FOUNDATION INVESTIGATION REPORT
FOR
HIGHWAY 169 UNDERPASS
W.P. 290-97-00, SITE 42-320
HIGHWAY 69, DISTRICT 52
HUNTSVILLE, ONTARIO

Job No. 97TF088A

June, 1998

**FOUNDATION DESIGN REPORT
FOR
HIGHWAY 169 UNDERPASS
W.P. 290-97-00, SITE 42-320
HIGHWAY 69, DISTRICT 52
HUNTSVILLE, ONTARIO**

**BOREHOLE LOCATION PLAN
AND SOIL PROFILES**

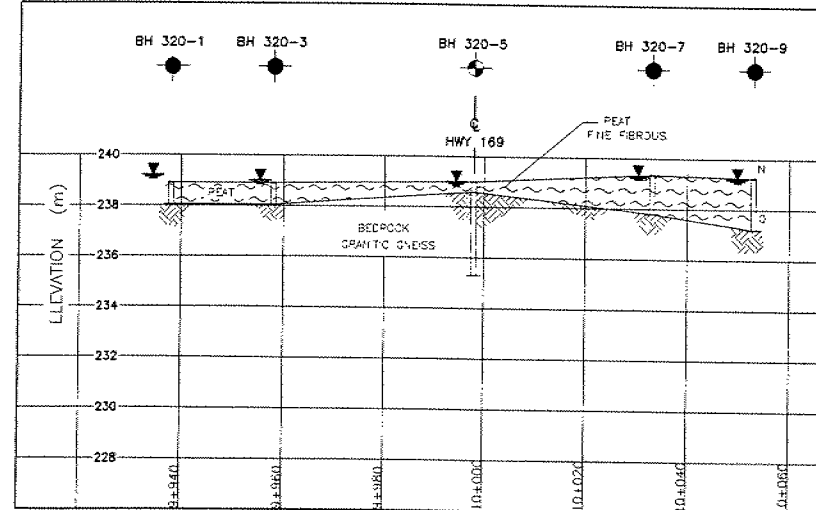
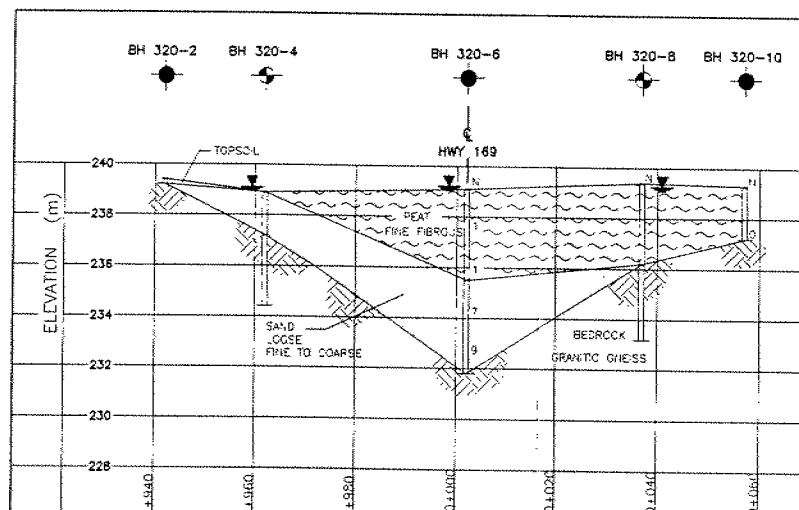
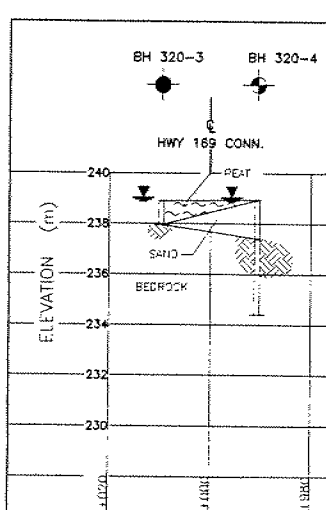
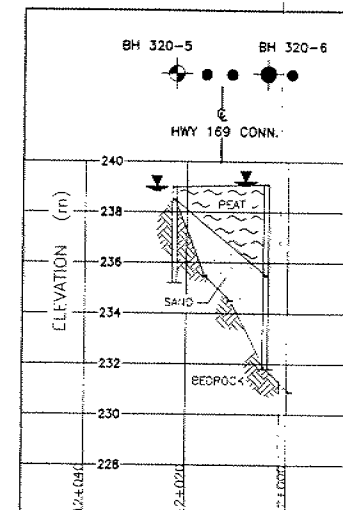
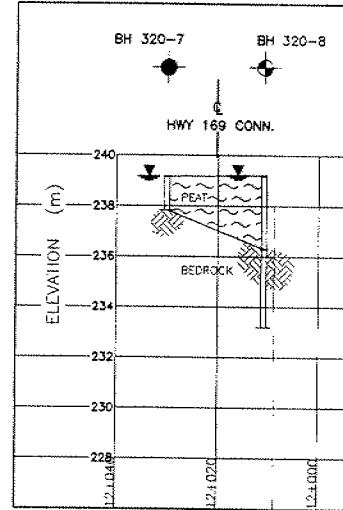
- Existing Hwy 169 should be shown on the Key Plan.
- Proposed foundation location should be shown on the plan.
- A large scale profile with a proposed grade of Hwy 169 should be provided.

- N-values and soil description should be provided on the cross sections and profiles.
- The cross sections are very small. When the drawing will be reduced to half size for the contract package, then it would not be legible. The cross sections should be produced in large scale. There is enough room on the drawing to draw cross sections in large scale.

- Proposed foundation location should be shown on the plan.
- Locations of the boreholes should be shown by coordinates, instead of stations and offset.
- N-values and soil description should be provided on the cross sections and profiles.
- The cross sections are very small. When the drawing will be reduced to half size for the contract package, then it would not be legible. The cross sections should be drawn in large scale.

- Proposed foundation locations should be shown on the plan.
- Locations of the boreholes should be shown by coordinates, instead of stations and offset.
- N-values and soil description should be provided on the cross sections and profiles.

- The cross sections are very small. When the drawing will be reduced to half size for the contract package, then it would not be legible. The cross sections should be produced in large scale.

DRAWING 3

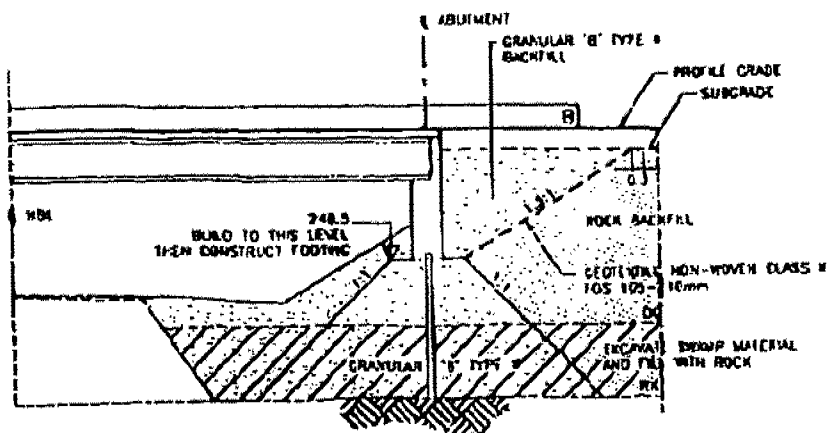
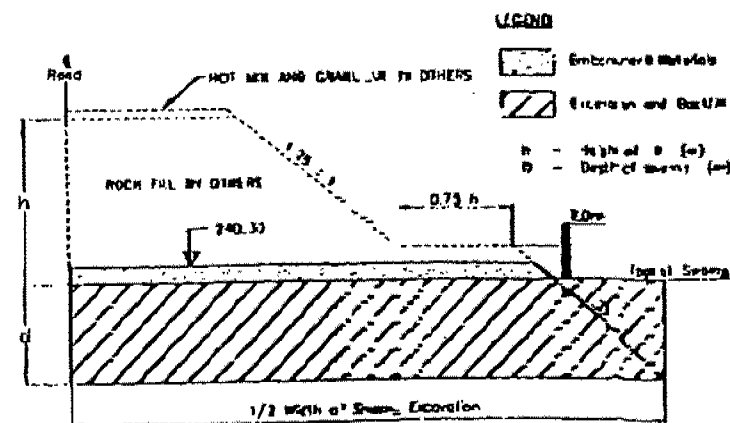
- As part of the advanced contract existing swamp east of Highway 69 will be excavated to the bedrock and backfilled with the rock to the elevation $\pm 240.30m$, approximately 1m above existing swamp level. Proposed final rock fill will be approximately 8m high at the Hwy 69 Connection and 2.4m high at S-E Ramp. As recommended in your May 20, 1998 letter we applied deep swamp treatment as detailed on drawing 3 (attached) under Hwy 169 Connection Sta. 10+085 to Sta. 10+200.

However, we noted that the borehole logs show auger refusal (probable bedrock) at the depth below 6m everywhere, except boreholes No. S1A-5(7.5m), S1A-6(7.95m) Sta. 10+150; S1A-8(6.2m) Sta. 10+175 Hwy 169 Connection and S1B-5(9.85m), S1B-7(9.1m), Sta. 11+950; S1B-8(6.2m) Sta. 11+975 Ramp S-E.

We wish you to clarify proposed deep swamp treatment.

Provided all materials are excavated to rock (max 6.0 m depth) the section requiring treatment in accordance with Drawing 3 may be reduced to 10 +125 to 10+200. The section from 10+085 to 10+125 may be treated in accordance with OPSD 203.010 (mod).

Treatment in accordance with Drawing 3 is not required at Station 11+950 to 11+975.
